REMARKS

Claims 1-35 and 37-39 remain pending in the application, with claims 1-29 and 34 having been withdrawn from consideration. Claim 36 has been canceled without prejudice or disclaimer, and Figures 1, 13, 14, 15, 16, 17, 18, 19, 21, 22, 26, 28, and 29 as well as claims 30-33, 35, and 37-39 have been amended without introduction of new matter. Favorable reconsideration is respectfully requested in view of the above amendments and the following remarks.

FIG. 13

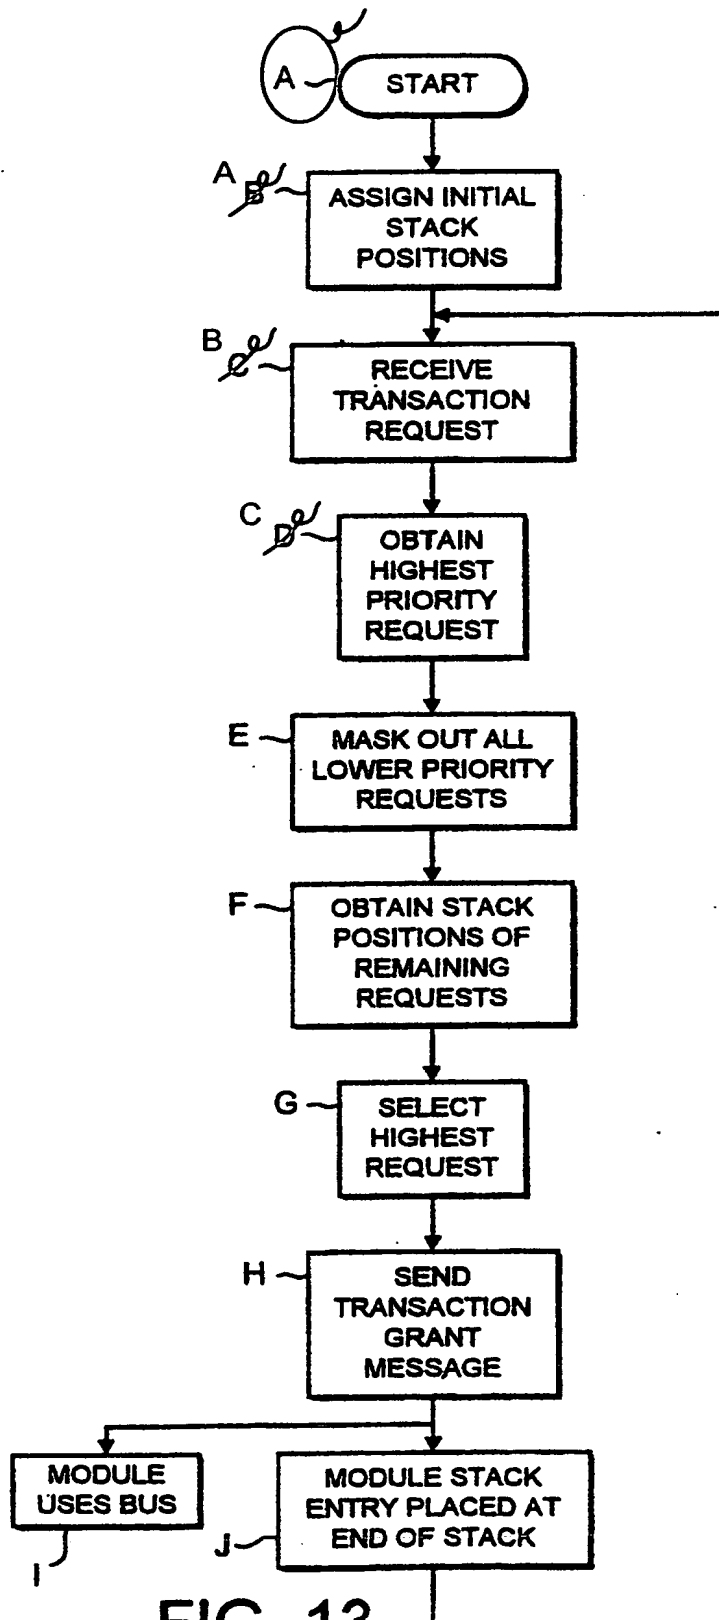
Figures 1, 13, 14, 15 16, 17, 18, 19, 21, 22, 26, 28, and 29 were objected to as failing to comply with 37 CFR §1.84(p)(5) because they include reference signs not mentioned in the description. In addition, Figure 13 was also objected to as failing to comply with 37 CFR § 1.84(p)(4) because:

- the reference character “A” has been used to designate both “start” in Figure 13 and “assign initial stack positions” on page 17, lines 15-17;
- the reference character “B” has been used to designate both “assign initial stack positions” in Figure 13 and “receive respective transaction requests” on page 17, lines 22-23; and
- the reference character “C” has been used to designate both “receive transaction request” in Figure 13 and “determine highest priority level” on page 17, lines 28-30.

With respect to Figure 13, this has been amended to delete the reference sign “A” from the block labeled “START”, and to re-label the blocks “B”, “C”, and “D” as “A”, “B”, and “C”, respectively. This cures the defect of reference sign “D” not being mentioned in the specification. This amendment also cures the above-mentioned defect of having some reference signs referring to one thing in the figure and another thing in the description. As to reference sign “H” in Figure 13, the Office’s attention is directed to the specification at page 18, lines 12-13, where this reference sign is already mentioned. Thus, no further amendment is necessary.
